# MARION

Early Design Guidance #2  
May 01, 2018  
SDCI# 3027315

## EDG Meeting #2 - Introduction and Purpose

EDG #1

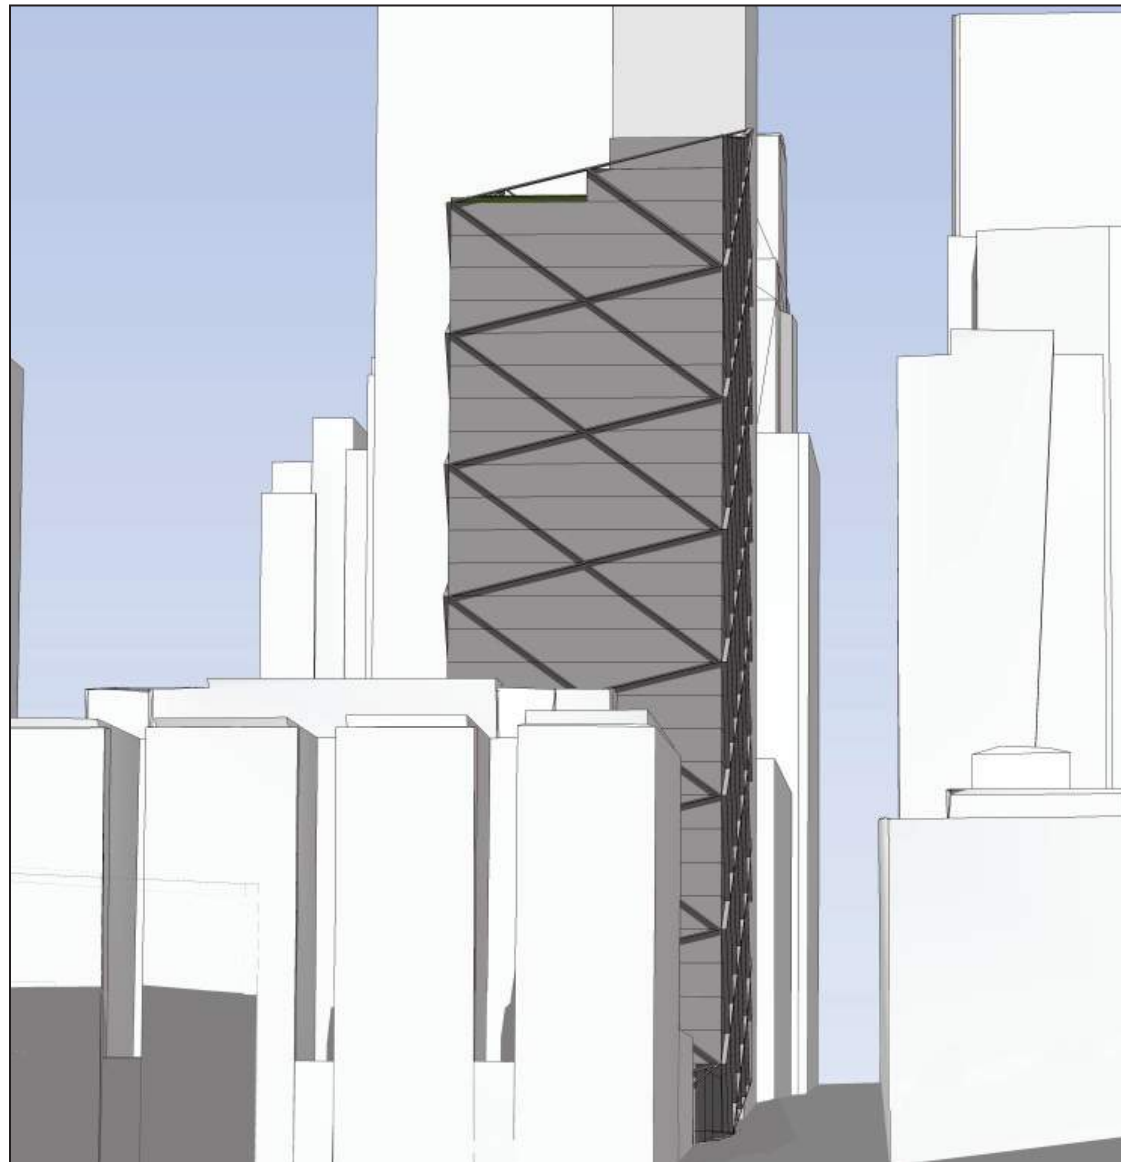
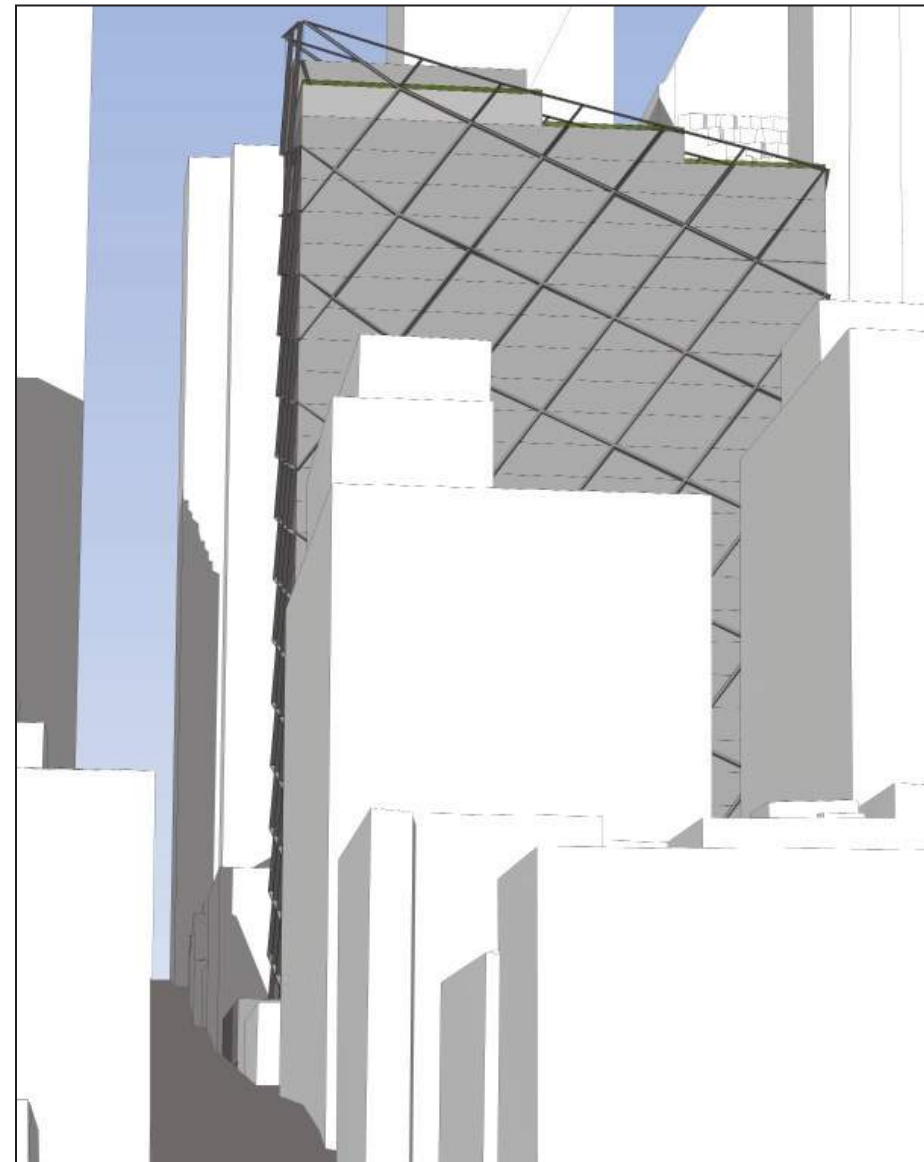
**Comment 1:** Massing Options and Related Departure: The Board noted that the variation in the proposed massing options were limited and also recognized the site constraints of the bus tunnel, which informed the approach to design the structure as an exoskeleton. While the Board supported the general idea of an exoskeleton, the Board was concerned with the smaller scale articulation proposed and the departure request related to modulation. Ultimately, the Board supported the exoskeleton design intent and directed the applicant to proceed with either Massing Options 2 or 3 while also studying different ways to address the modulation requirement through massing alternates. (A2, B1, B2, C2).

**Comment 1a:** The Board indicated they did not support the departure request as shown and recommended studying ways to modulate the building within the framework of the exoskeleton to strengthen the departure request. The Board agreed the design should fulfill the intent of the Code in a way that creates transitions in height breaks up the massing. To resolve the modulation requirement, the Board requested massing alternates and encouraged study models for the next meeting. (A2, B2, B4, C2).

**1a Response:** In response to the Board's input regarding better meeting the 'intent' of the modulation requirement through alternate massing options, the design team studied a series of approaches to break up the overall massing by means of facets or 'folds' in the long sides of the building, including evaluating both outward and inward shaping of the floor plates. The proposed structural scheme ('exoskeleton') as discussed at the initial meeting utilizes a series of columns and diagonal bracing at the building perimeter in lieu of a more typical central core; this system has capacity to integrate some degree of 'bends' between structural bays and still be efficient, and was the primary approach to shaping the building mass.

Based on these explorations, the team arrived at the proposed massing scheme which introduces an inward 'fold' along 3rd Avenue, which is 10 feet at the deepest point, and a similar but asymmetrical outward projection on the alley side. These facets strongly emphasize the dynamically arranged structural frame, and compose the building mass into more discreet volumes over the height of the tower. The inward fold on 3rd Avenue is a strong gesture that is substantially consistent with modulation intent outlined in the code, but more subtle and appropriate to the overall project design language. The extension of the floor plates over the alley side occurs within the partial vacation zone controlled by the Owner, and serves to balance the overall floor area while creating articulation on the bay facing façade.

It should also be noted that the project program has expanded to include an additional (6) floors, which work well proportionally with the more articulated volumes.

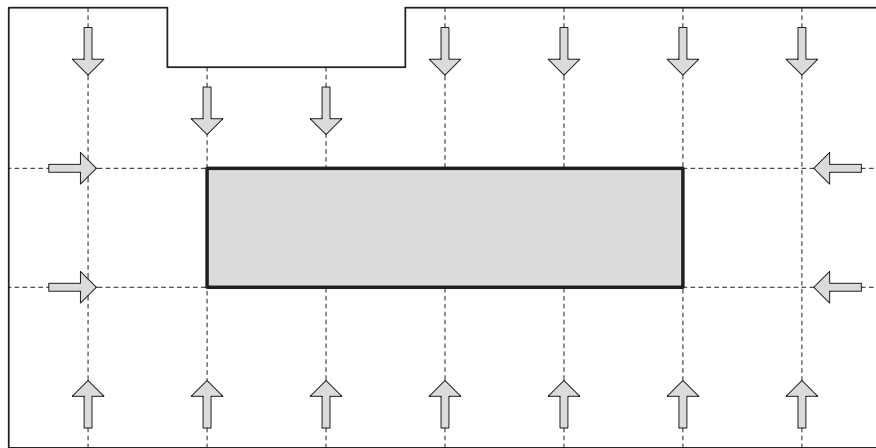
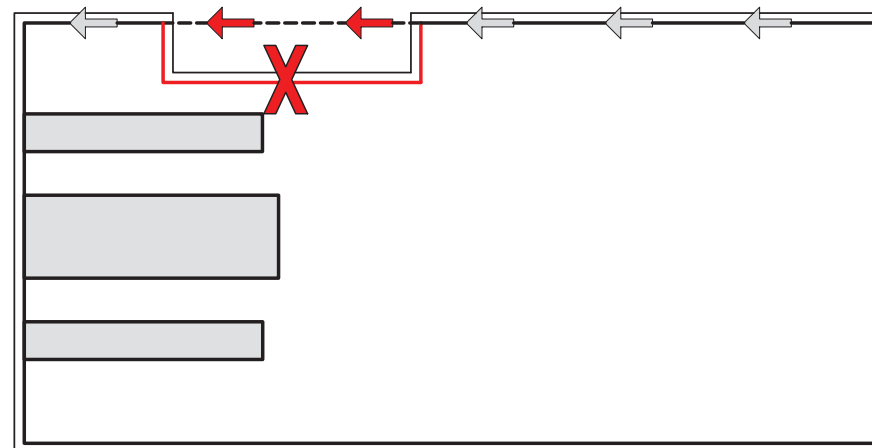
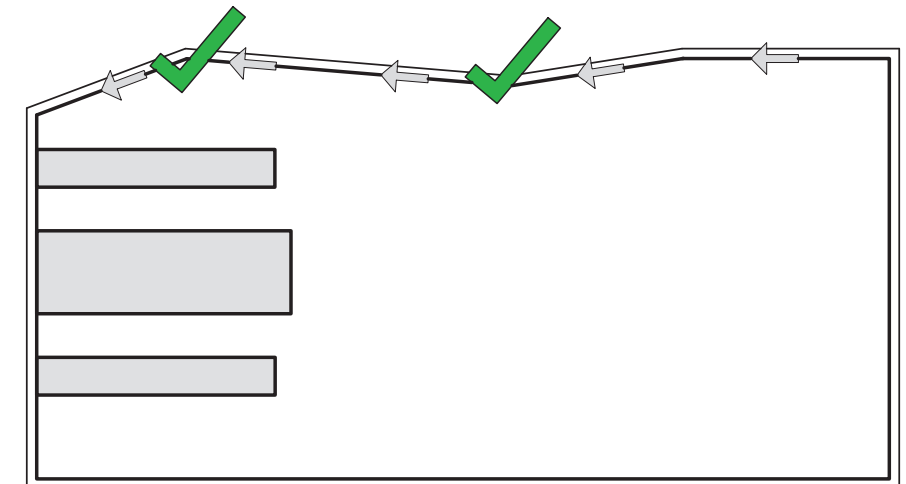
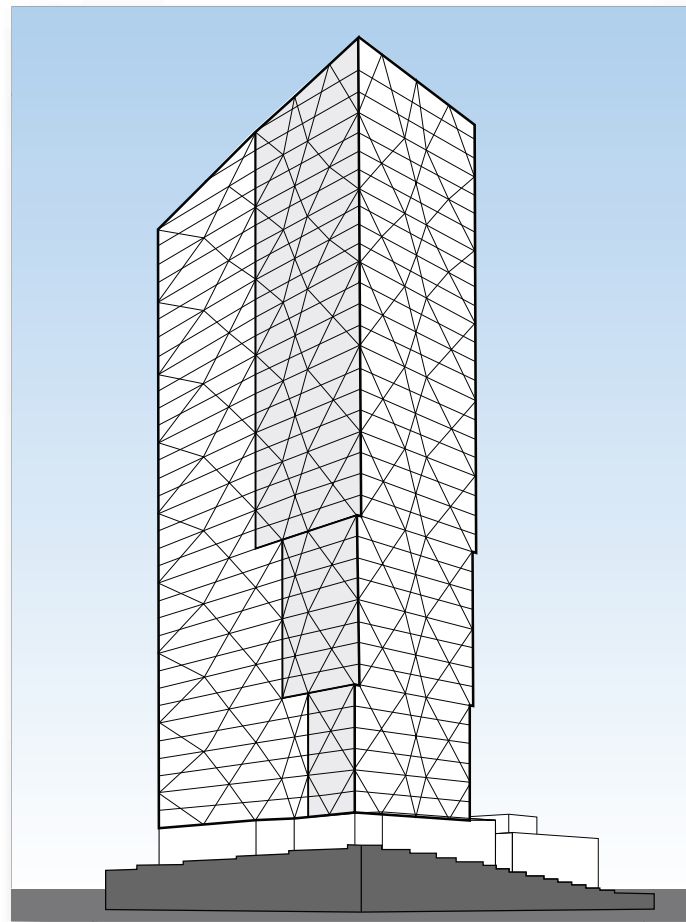
**Comment 1b:** The Board agreed that resolving the articulation and depth of the exoskeleton expression is critical to the design and noted that many of the precedent images show greater depth, texture and articulation rather than the proposed treatment. In order to demonstrate meeting the intent of modulation, the Board recommended expressing the structure on the outside with legible depth, texture and shadow. (A2, B4, C2)

**1b Response:** The preliminary proposal was for a largely rectangular massing, and as the Board has noted, would rely heavily on the articulation of the façade expression to provide an appropriate level of detail and character to the façade. The team has studied several approaches to implementing this expression including as a three dimensional element applied to the façade illustrated in preliminary images, as well as more integrated methods such as glass patterning (frit) or through inset reveals within the glazing modules, such as seen in many of the reference buildings initially presented. Each of these approaches would serve to be a graphic representation of the actual building structure behind the façade, but would need to be of sufficient dimension and proportion to be legible at an urban scale, that they would be visually 'competing' with the actual building structure behind.

As an alternative approach, and given the revised massing, the use of 'sculpted' vertical glass or metal fins is proposed, arranged with gaps / void spaces following the pattern of the exoskeleton grid and more directly reveal the actual structural system. The fins would vary in depth, and provide an additional subtle layer of texture to the façade, as well as provide a degree of solar shading and glare control to the interior. Use of color and / or lighting of the internal structure will be explored, in conjunction with the materiality of the fins, to provide visual contrast and create a more layered facade than the direct representation expression initially explored.

TYPICAL TOWER PLAN- EDG #1

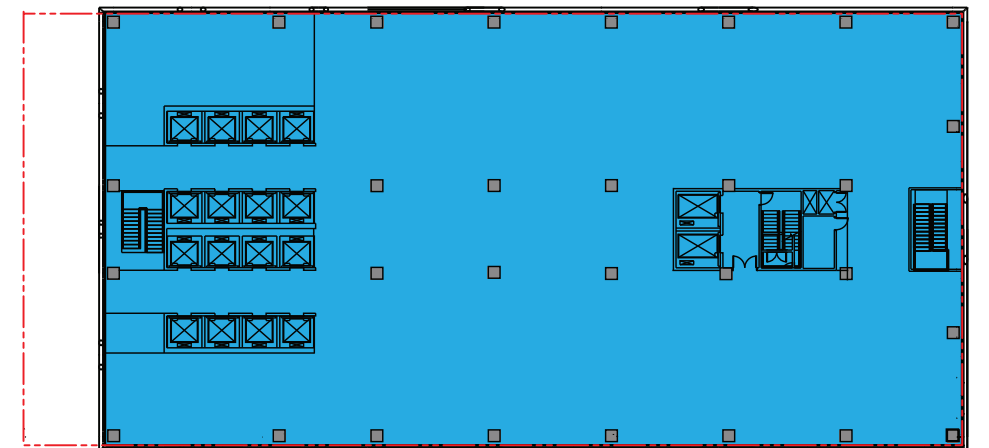
**Comment 1c:** The Board also viewed the potential for modulation between the structural system and the curtain wall as an opportunity to further articulate the form and justify the related modulation departure. The Board recommended recessing or projecting the façade skin from the structure in areas, similar to the Leadenhall Building and Seattle Public Library precedent images shown on pg. 53 of the packet. (A2, B4, C2)

**1c Response:** The updated massing approach creates the opportunity to modulate between the internal structure and building skin within the faceted extension on the west (alley side); the floor structure is cantilevered beyond the structural frame over the alley, which creates unique 'occupiable' zones with the building envelope as well as differentiating the west facing tower mass from the east facing inward articulation. The internal structure then becomes a defining interior element for those zones.

## EDG #2

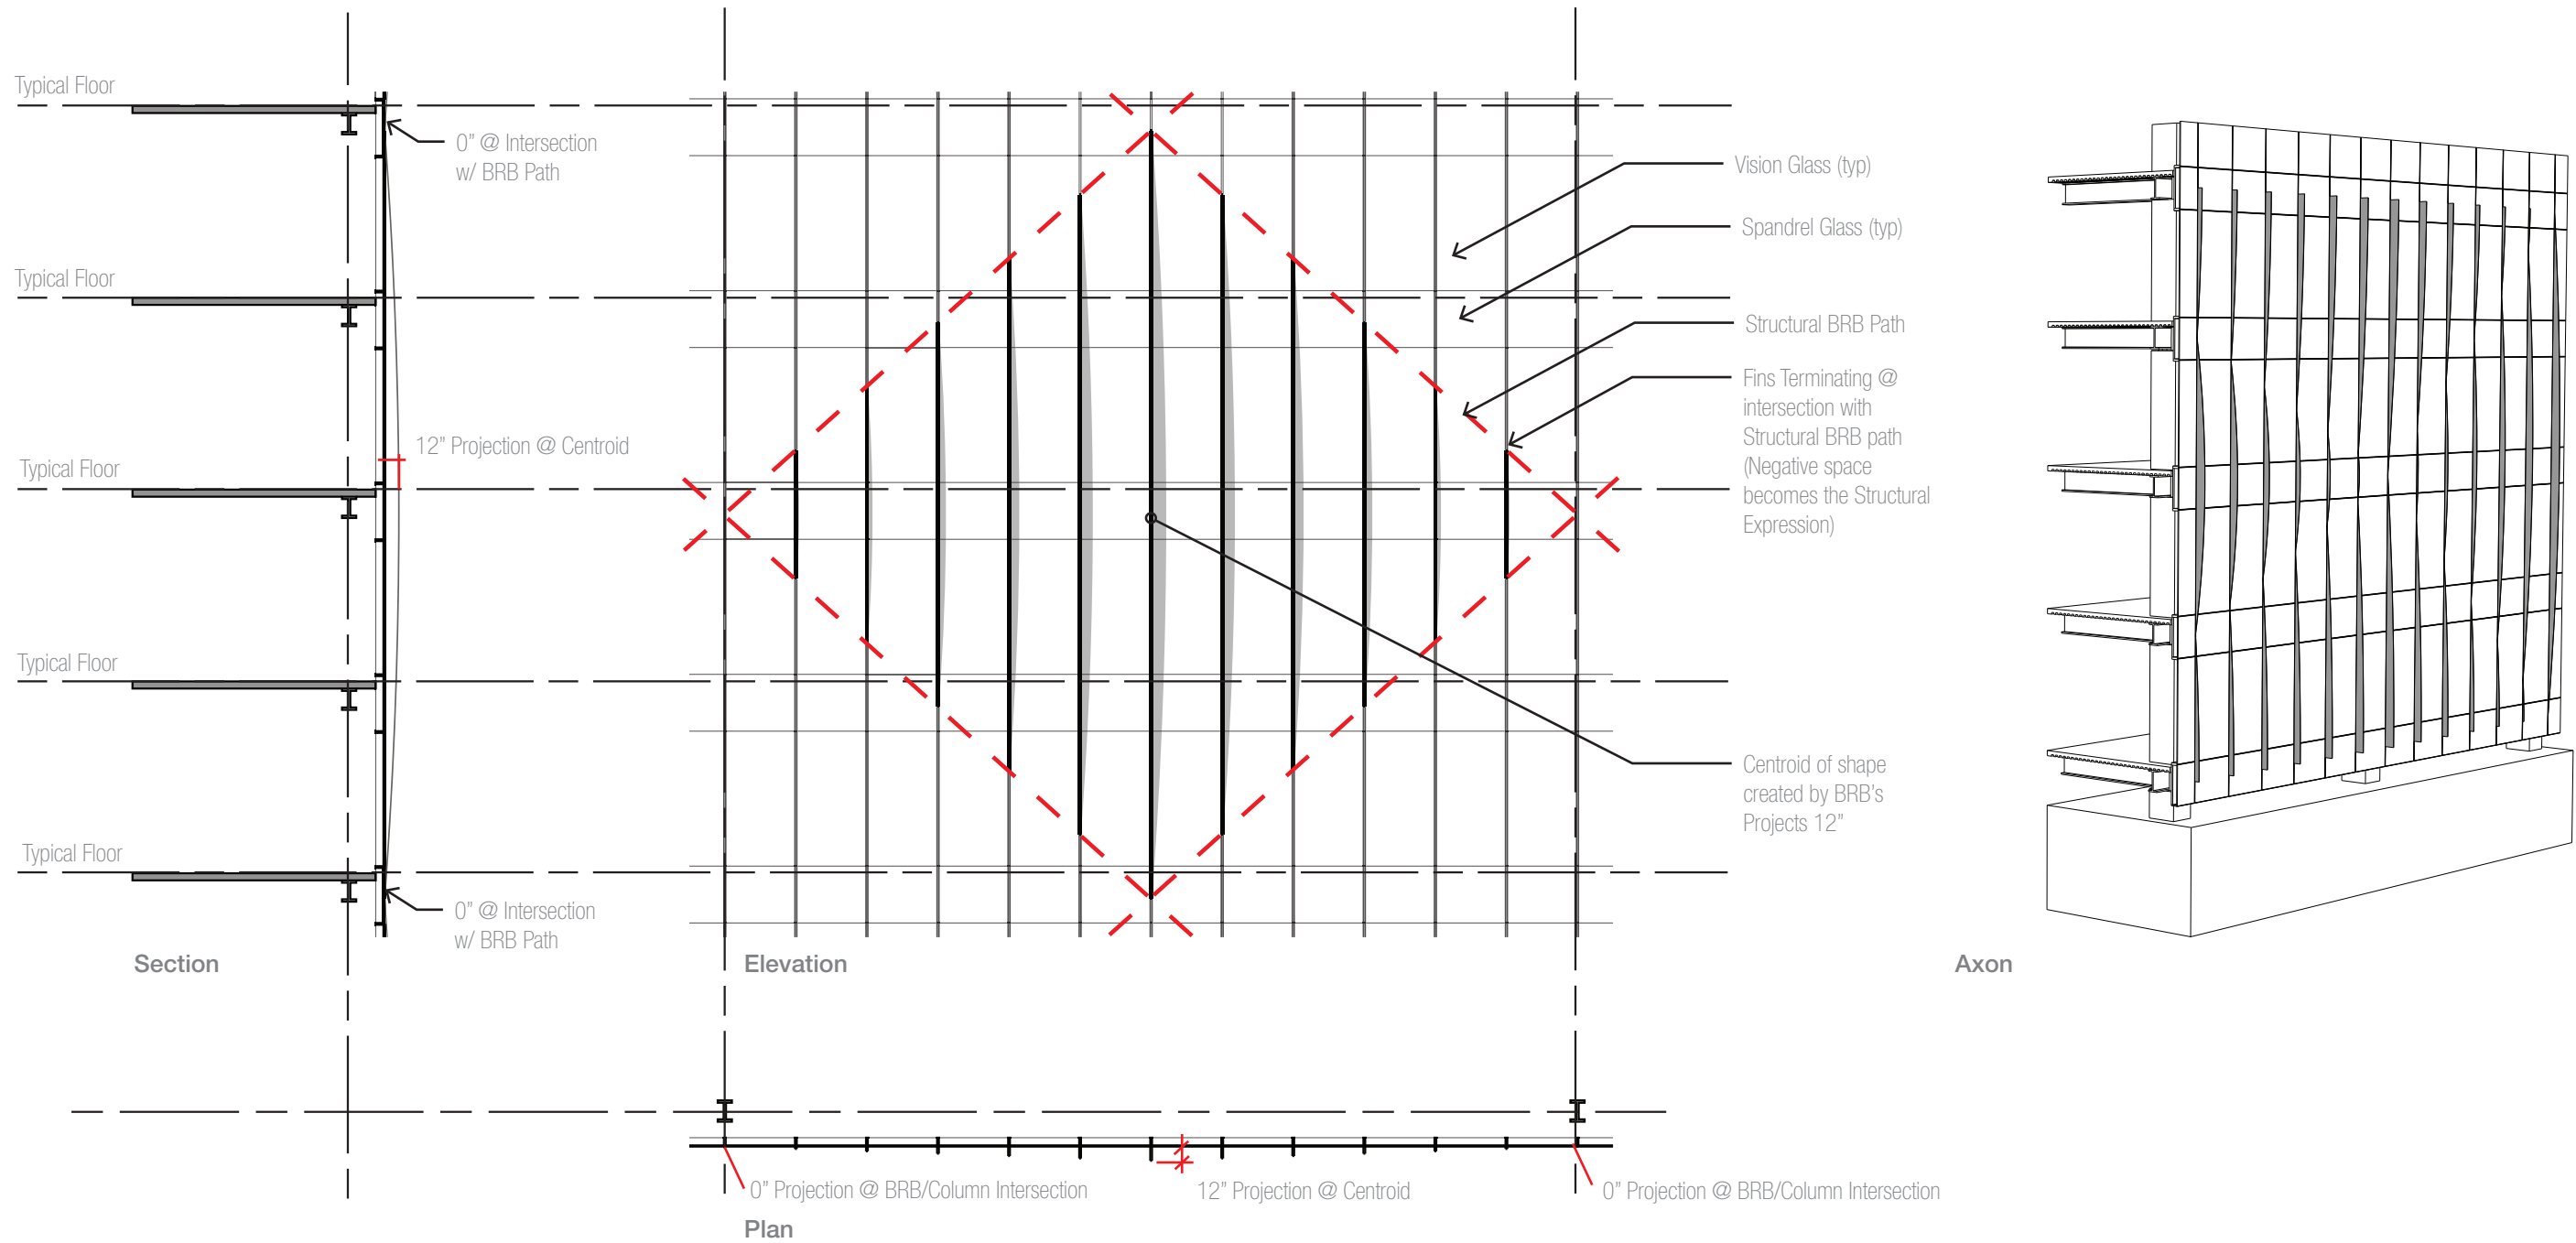
**Comment 1d:** The Board stressed the importance of carrying the logic of the exoskeleton through the entire tower form to create a coherent and unified design and acknowledged public comment related to the ground plane. To improve the streetscape experience and justify the departure related to street level uses, the Board recommended adding an indoor/outdoor space along the streetscape which could reveal the structure in a significant way. (B4, C1, C2, D1.1)

**1d Response:** The revised proposed design better integrates both the top and the base of the building within the overall modulation geometry and tie the faceted language to the ground plane; the 'fold' articulation along the 3rd Ave façade creates a clear entry zone at the street, and a break in the roof line further emphasizes the massing modulation.

As an alternative approach, and given the revised massing, the use of 'sculpted' vertical glass or metal fins is proposed, arranged with gaps / void spaces following the pattern of the exoskeleton grid and more directly reveal the actual structural system. The fins would vary in depth, and provide an additional subtle layer of texture to the façade, as well as provide a degree of solar shading and glare control to the interior. Use of color and / or lighting of the internal structure will be explored, in conjunction with the materiality of the fins, to provide visual contrast and create a more layered facade than the direct representation expression initially explored.
